SBK-L-11245

Seabrook Station

License Amendment Request 11-04

Changes to the Technical Specifications for New and Spent Fuel Storage

Figure 3.9-1  
Fuel Assembly Burnup vs. Initial Enrichment  
For Spent Fuel Assembly Storage

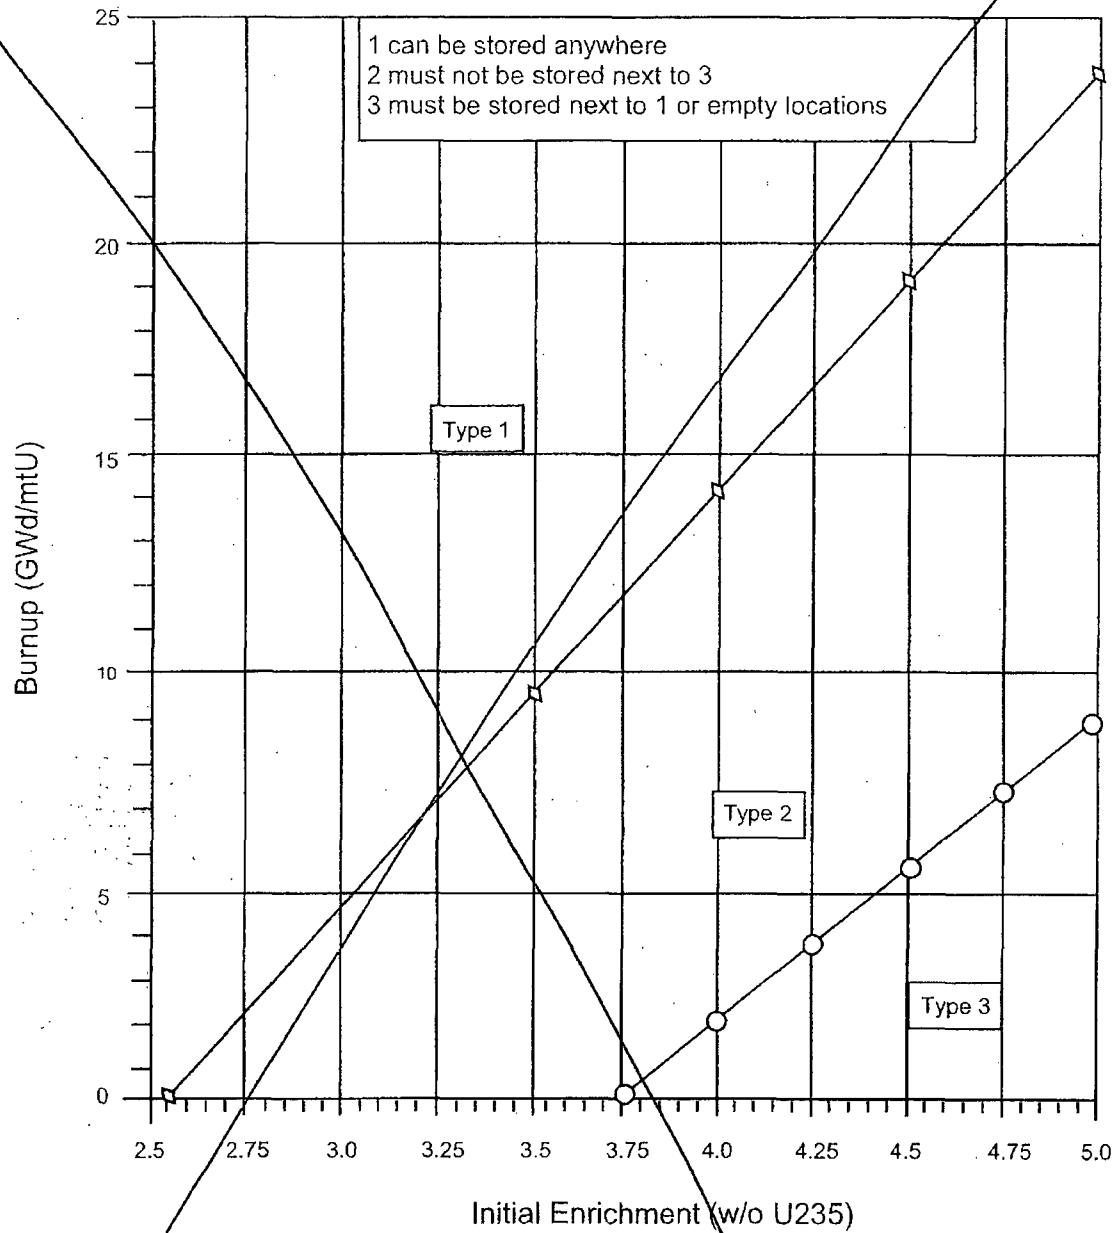
Figure 3.9-1

Figure 3.9-1 is deleted and replaced as follows; (1) the burnup and enrichment requirements are moved to Section 5.6.1 and (2) the burnup and enrichment requirements are converted to tabular form (Table 5.6-1).

DELETE

Justification: This change is editorial. All fuel storage requirement data is being relocated to the Design Features (TS 5.6)

ALLOWABLE STORAGE PATTERNS REGION 2 (See Note 1)

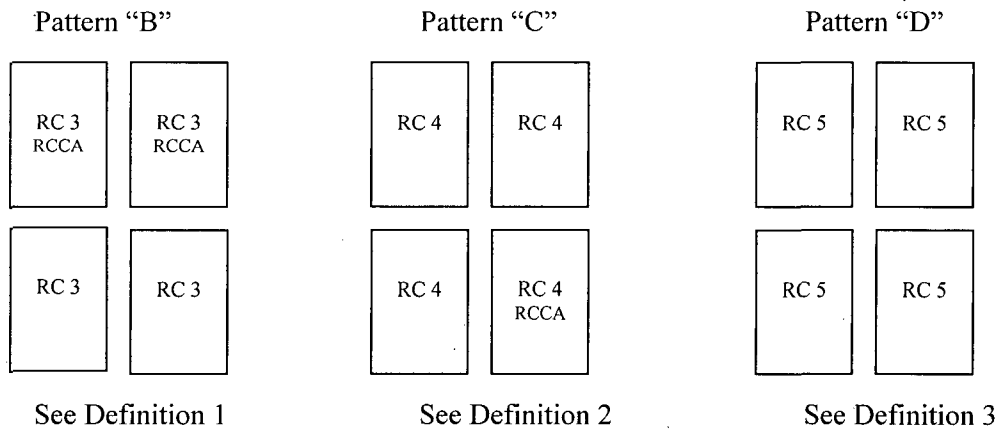
Figure 5.6-2

Figure 5.6-2 is added to provide the Region 2 storage arrays allowable for placement of fuel.

Justification: The revised spent fuel storage patterns align with the criticality analyses described in this evaluation and in Attachment 2.
